Town of Davidson
Historic Preservation Commission Regular Meeting
Town Hall and Community Center
Community Room 120
251 South Street
Wednesday, October 16, 2024 at 5:30 PM

Date: October 16, 2024
To: Historic Preservation Commission
From: Lindsay Laird, Senior Planner
Re: Davidson College, With These Hands Memorial – Informal Review #1

Date: October 16, 2024
To: Historic Preservation Commission
From: Lindsay Laird, Senior Planner
Re: Oak Row – Informal Review #1

Davidson - Oak Row Rehabilitation

A	Concept Plan 0 4' 8' 16' 1/8" = 1'-0"

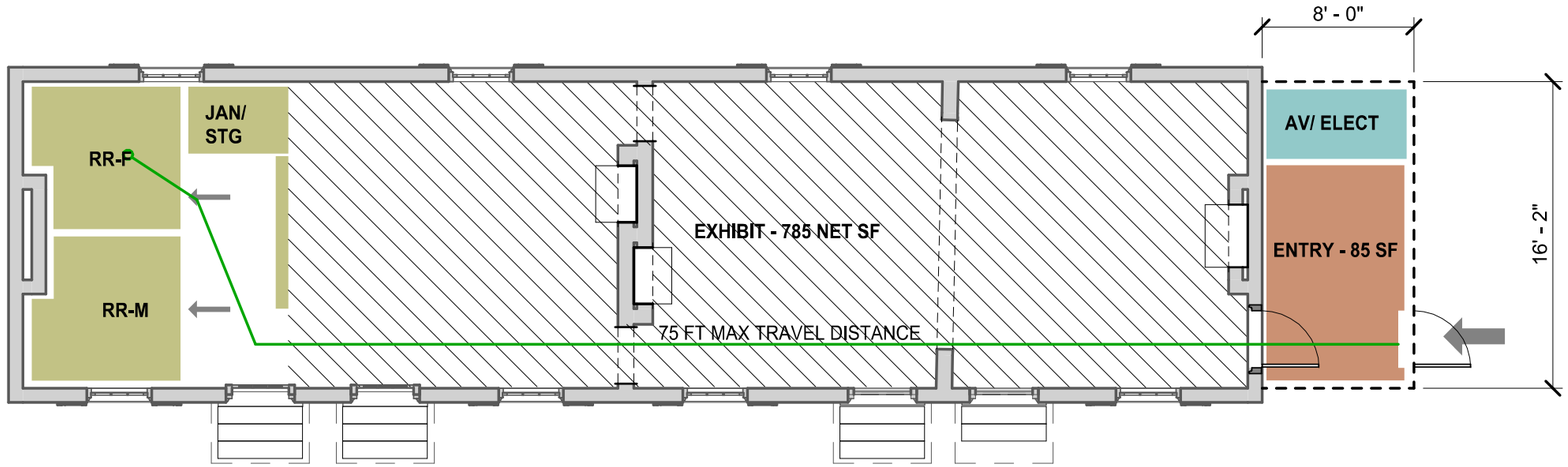
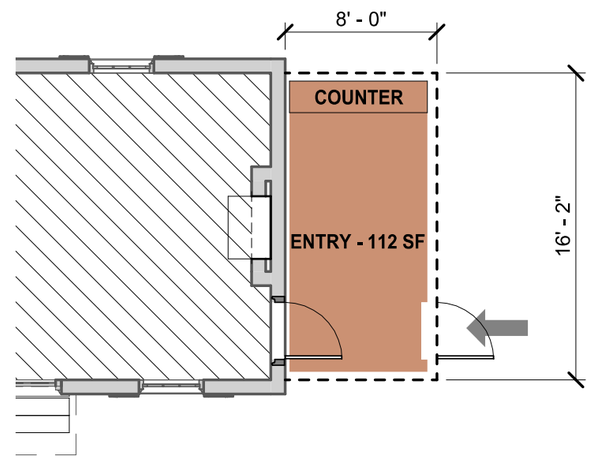
E. **Additions to Historic Buildings (Pg. 40-41):** *Proposed plans show a small 112 SF addition to the north end of the building to provide an accessible entrance. Grades can be modified to achieve accessible entry without a ramp.*

A1 Massing Concept

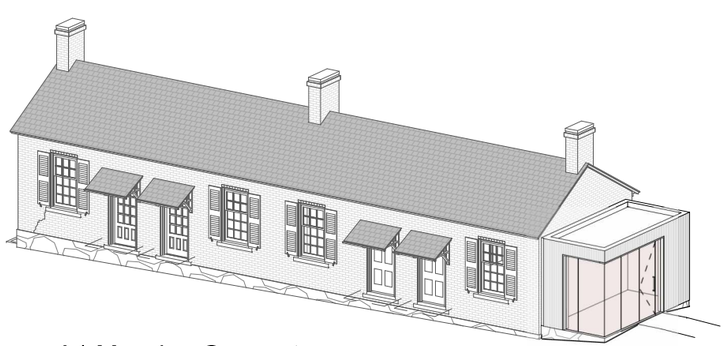
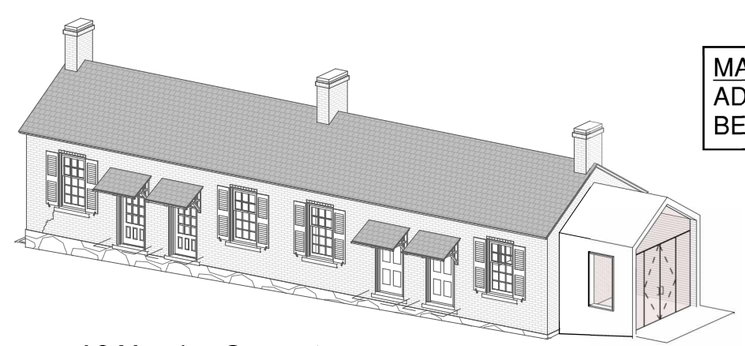
4. Design additions so they are compatible with the existing building in height, massing, and roof form and pitch. *The HPC should provide feedback on the compatibility of massing and roof form/pitch of two addition concepts.*
